DYM TRACT
MASTER DEVELOPMENT PLAN

MDP PLAN NO.: 039-06

Re: **DYM Tract** **MDP # 039-06**

The City Staff Development Review Committee has reviewed DYM Tract Master Development Plan **MDP # 039-06**. Please find enclosed a signed copy for your files. Your plan was approved for acceptance, however please note the following:

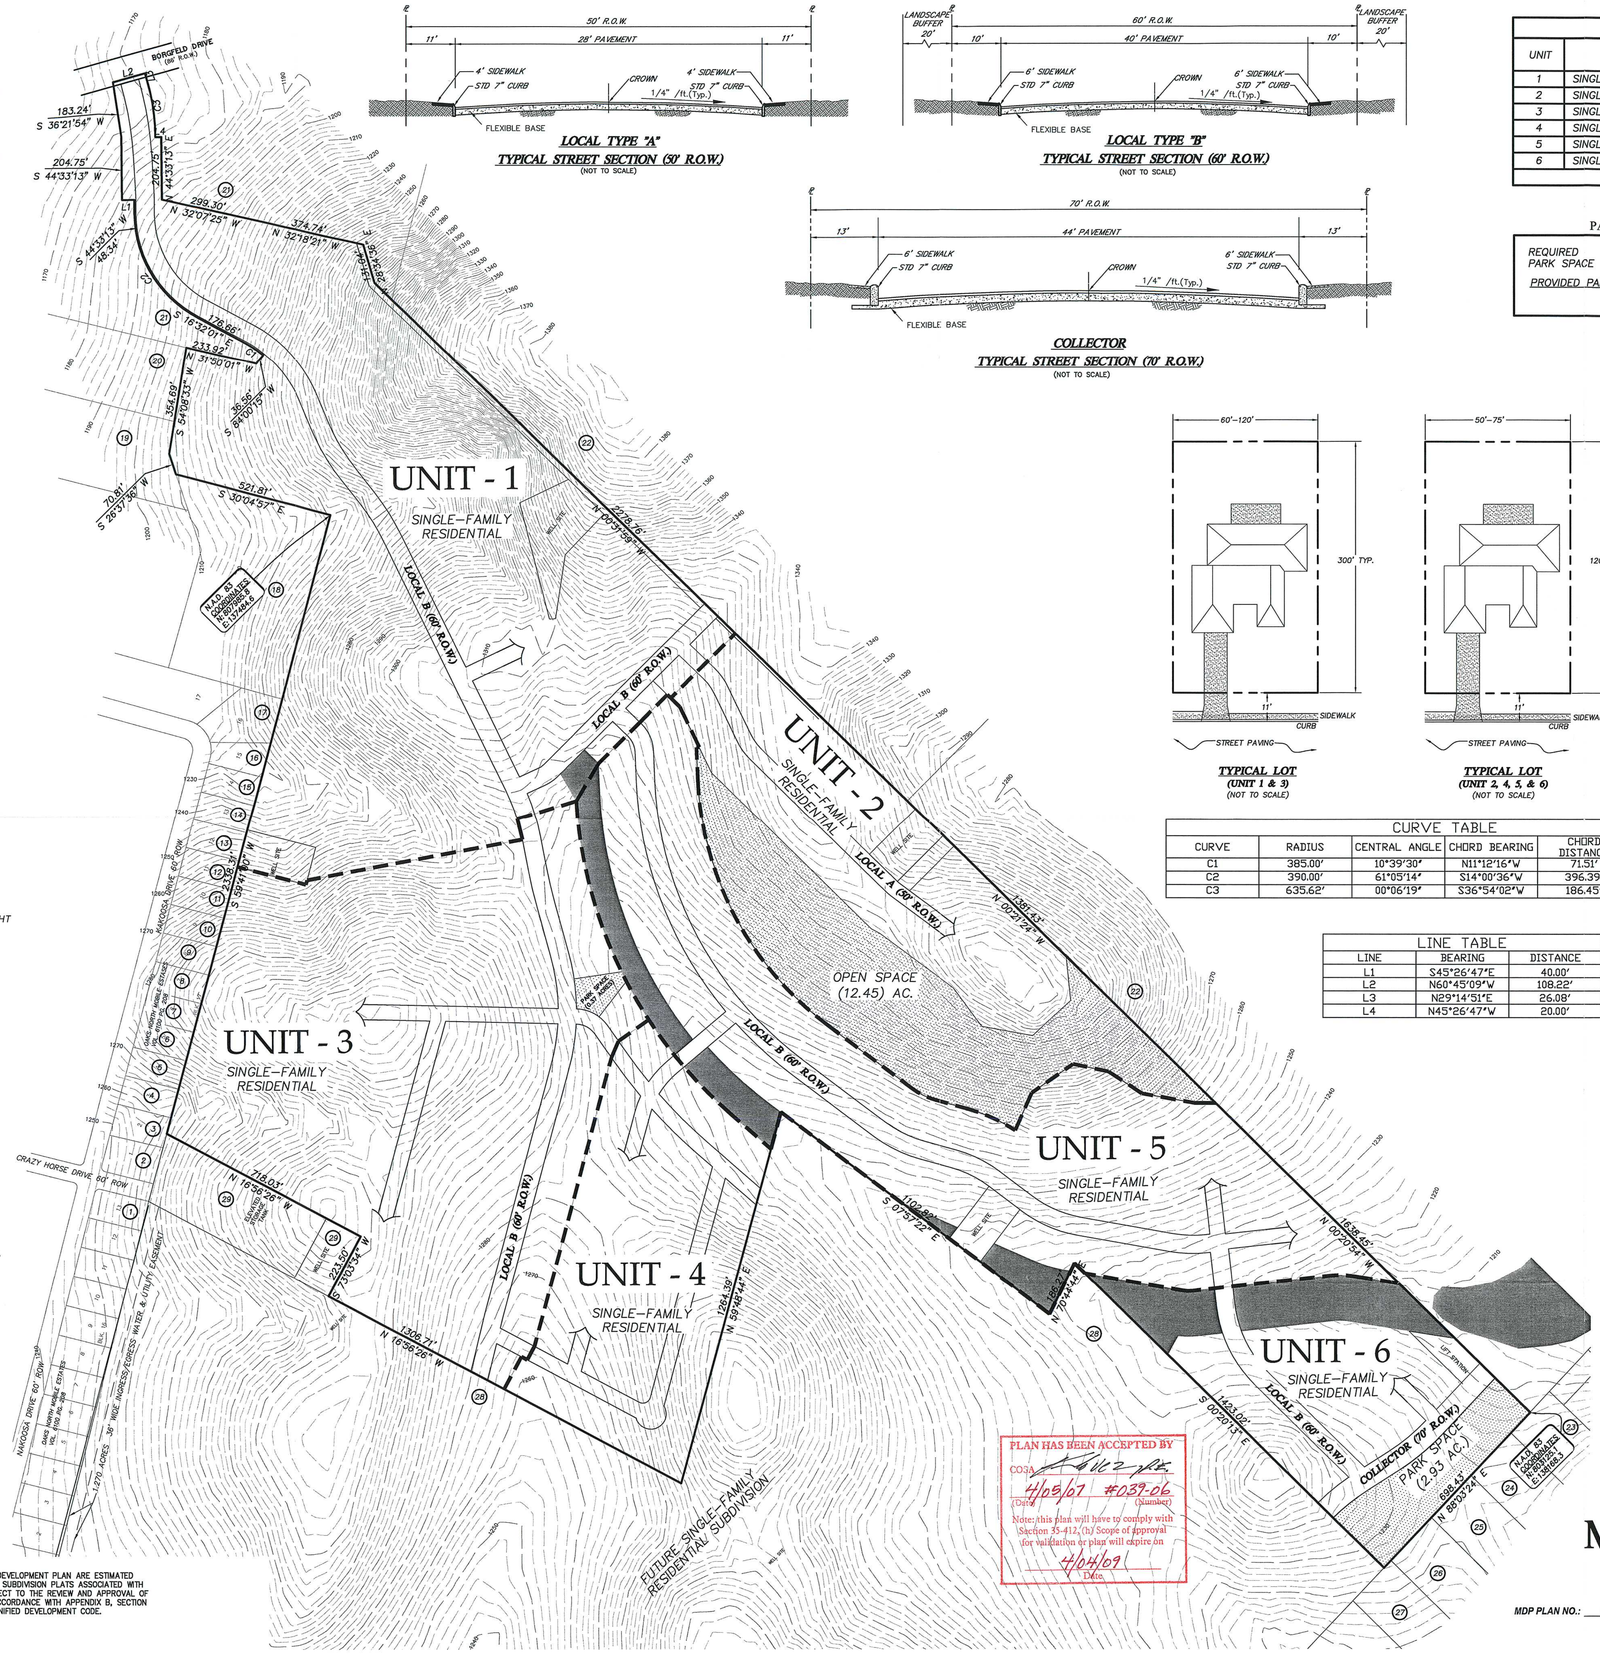
Traffic Impact Analysis & Streets Division has reviewed the Level-1 Traffic Impact Analysis (TIA) and the MDP plan for DYM Tract. The Streets and TIA division recommends approval and has no comments to return to the engineer and the analysis indicates the report is in compliance with TIA Ordinance 91700 and the UDC. Listed below are some of the requirements and onsite improvements that are necessary and shall be provided by the developer, on and before the completion of any plats, at no cost to the City of San Antonio:

The developer shall be responsible for providing a left-turn lane, with storage length and bay taper per TXDOT or ASSHTO standards as it relates to the submitted TIA traffic counts, at Borgfield and proposed Local B Street, coordination with Capital Projects at the County will be required for installation of left turn lane – (UDC)-35-502 (a)(7), subsection C.

Parks and Recreation Department has indicated as part of their approval, the following conditions shall be met:
DYM Tract is a proposed subdivision with 367 single-family residential units. UDC Section 35-503, Table 503-1 states that single-family development is required to provide 1 acre of park/open space per every 70 dwelling units. The requirement for this development is 5.24 acres. This subdivision provides 3.13 acres of park space dedication (2.93 acres and .2 acres out of a .37 acre tract). In addition, this subdivision will provide a playground for 1.25 acres of credit, a picnic area for .25 acres of credit, and an open play area for 1.0 acres of credit for a total of 5.63 acres of park land dedication.

- The parkland provided shall be shown as "Park" or "Open Space" on a plat; UDC section 35-503(e) *Designation of Parkland.*
- Parkland dedication shall be platted by the second phase of residential development; UDC Section 35-503(f) *Development Phasing.*
- The parkland provided shall be dedicated to the Home Owners Association.

- Secondary access must be secured prior to the approval of any plat or combination of plats exceeding 125 dwelling units as per UDC 35-506(e)(7).

- Coordinate with Bexar County Capital Project Section to include a westbound left-turn lane in the design of Borgfield Road improvement project.
